Schematics of gaseous TPC – part of T2K Near Detector complex.

Application of PE laser in DUNE

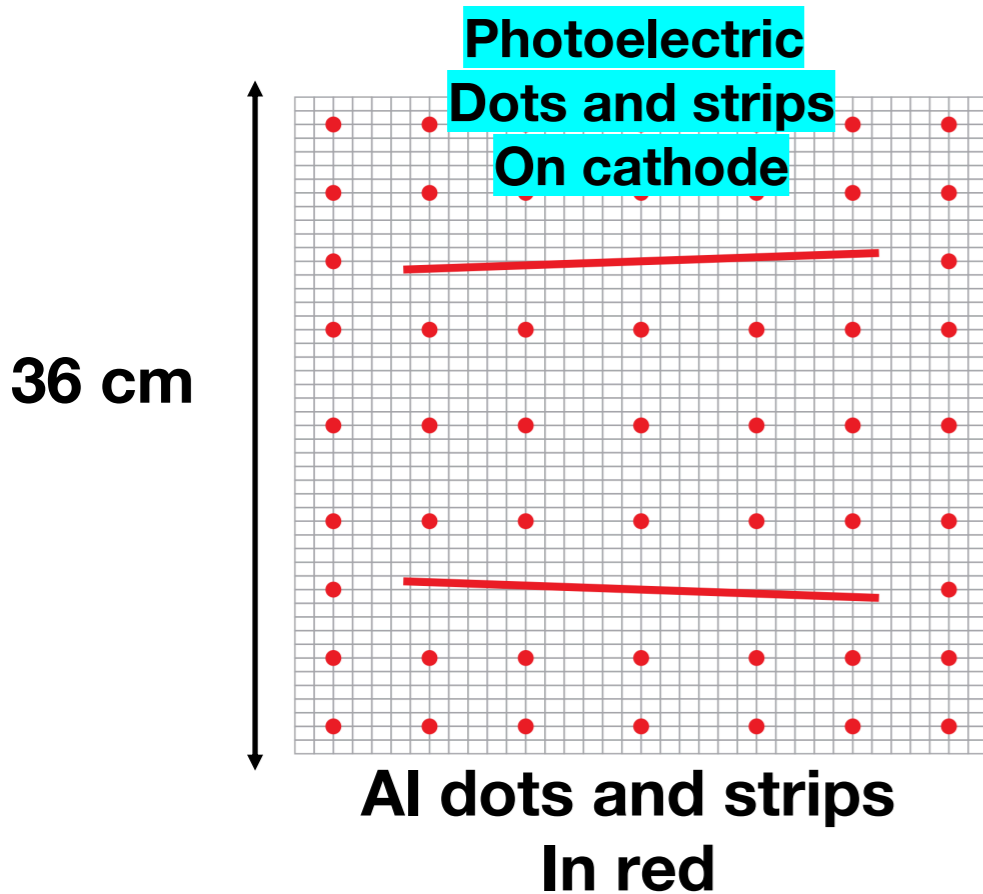
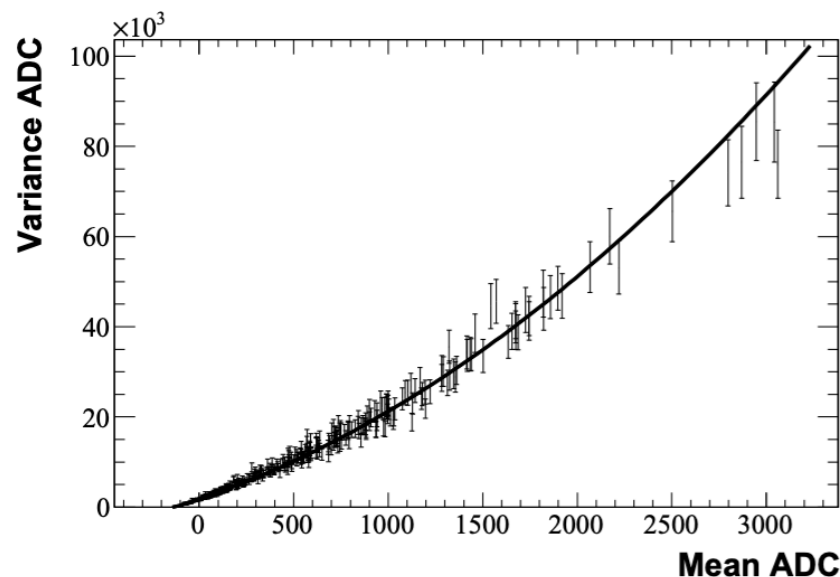
Q1. How was this system used in the T2K near detector?

- 266 nm NdYag laser used for illumination
- 100 pe's per dot
- 2 pe/mm² from Al and 0.03 pe/mm² from Cu
- Data collected during 3.5 s inter-spill periods during the beam run

- measured electron drift velocity and distortions due to misaligned and inhomogeneous **E** and **B**.
- displacements measured at 0.1 mm
- measure absolute readout gain
- angled strips used to measure transverse **E** field distortions

Kapton Simulation

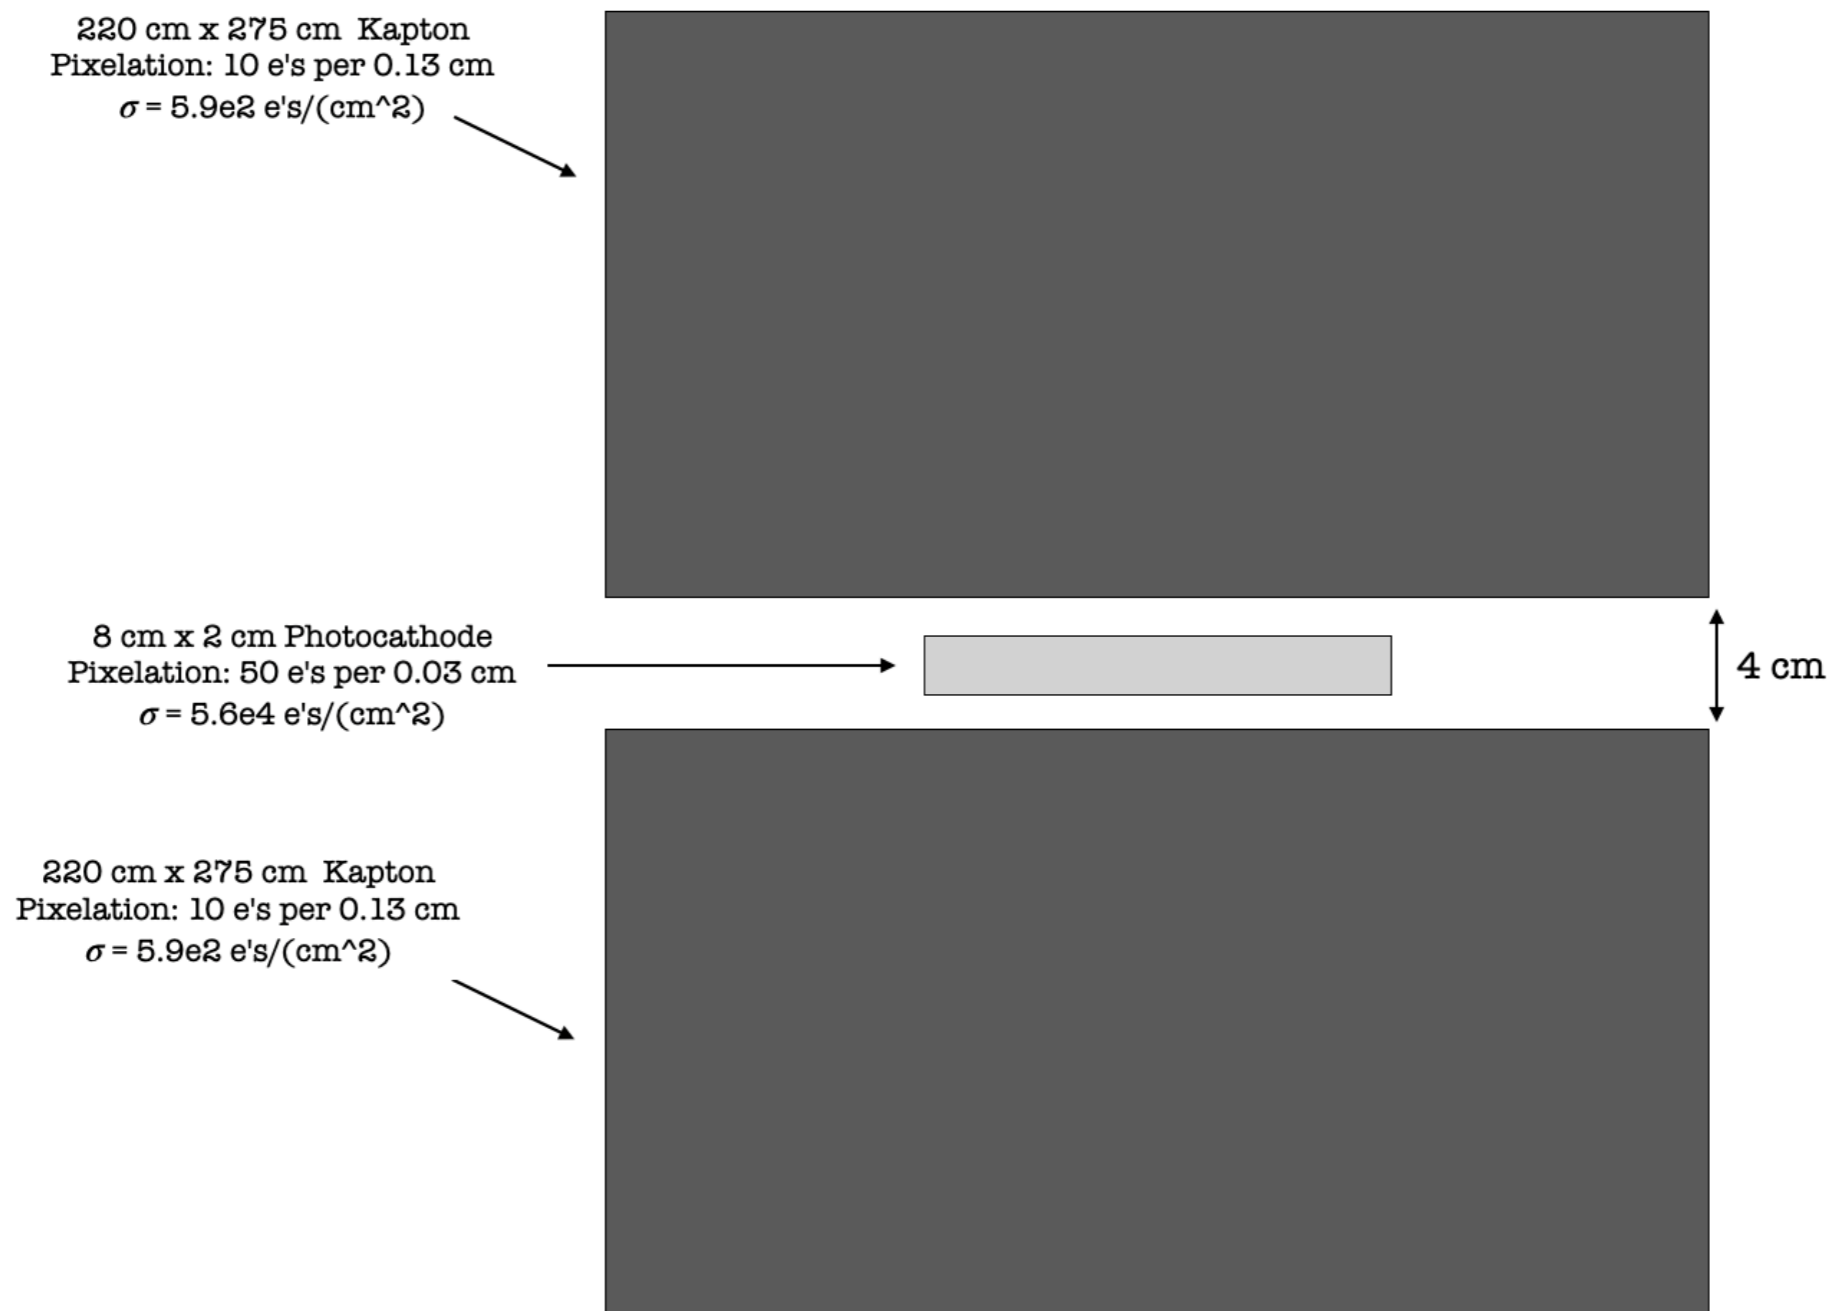
Q5. On slide 20 of Jelena's presentation, it indicates that a 5m illumination radius is anticipated. Is this from a single fiber? This would be about the correct size to illuminate the entire cathode plane surface parallel to a single APA. Should we be concerned that the resulting emission of electrons from all of the targets and brass connectors will produce a signal in every readout channel of the APA making it impossible to identify the electrons associated with specific targets?

Carried out simulation studies of photoelectric effect in Kapton and how to observe the reconstructed signal from photoelectric targets on top of Kapton.

Studies exemplify how we can distinguish targets on top of Kapton signal, based on their collection and induction wire signals.

Simulation includes photoelectric emission from two large Kapton areas (220 cm x 275 cm) with 100 times lower QE than Al (will be tested in the lab).

Simulation includes photoelectric emission from Al strip 8 cm x 2 cm.

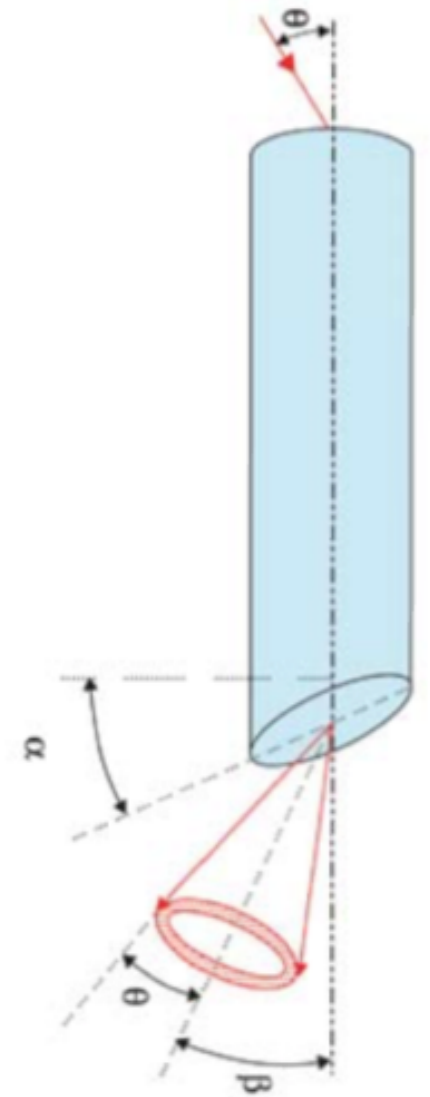
Q6. What is the range of opening angles for the Polymicro quartz fibers? How small of an illumination diameter is possible including the effects of diffusion in the LAr?

- The angle of divergence (opening angle) θ is 25.4° deg in air and 20.6° in LAr.
- It is equal to the angle that the traveling light makes with the axis of the beam, so it cannot be varied by more than a few degrees as can be seen in the picture.
- The pointing angle (β) depends on the angle (α) at which the “distal” end is cut. We can thus illuminate entire length of CPA from fibers at the top of APA.
- There is enough space between the APA and we can modify the holder to accommodate more fibers.

Opening angle from spec. =22 deg

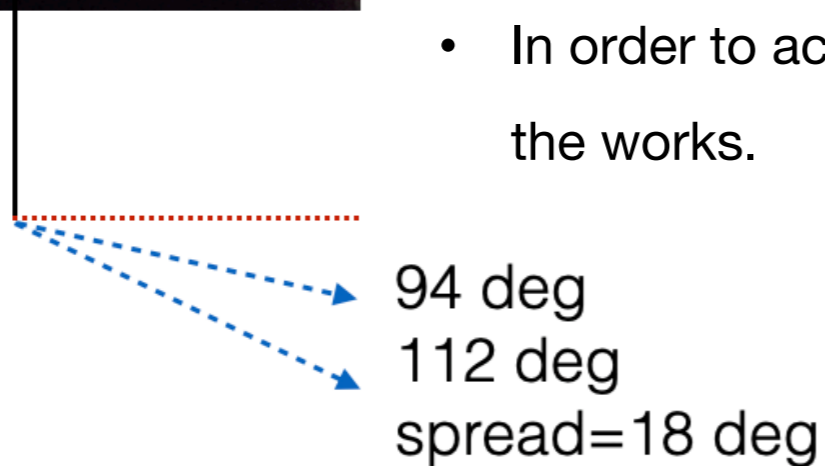
Q6. What is the range of opening angles for the Polymicro quartz fibers? How small of an illumination diameter is possible including the effects of diffusion in the LAr?

- Photo of the preliminary test to check the angular light output as claimed by the manufacturer.
- Accurate tests of light intensity and spread will use better light injection, not a handheld laser pointer like in the photo.
- In addition to subpar injection the phone camera sensor response also played into the image shown.
- The measurement setup will include a light sensor with powermeter that can be moved in x-y direction on the screen to characterize light pattern.
- In order to accurately orient fiber, we will use a fabricated holder which is in the works.
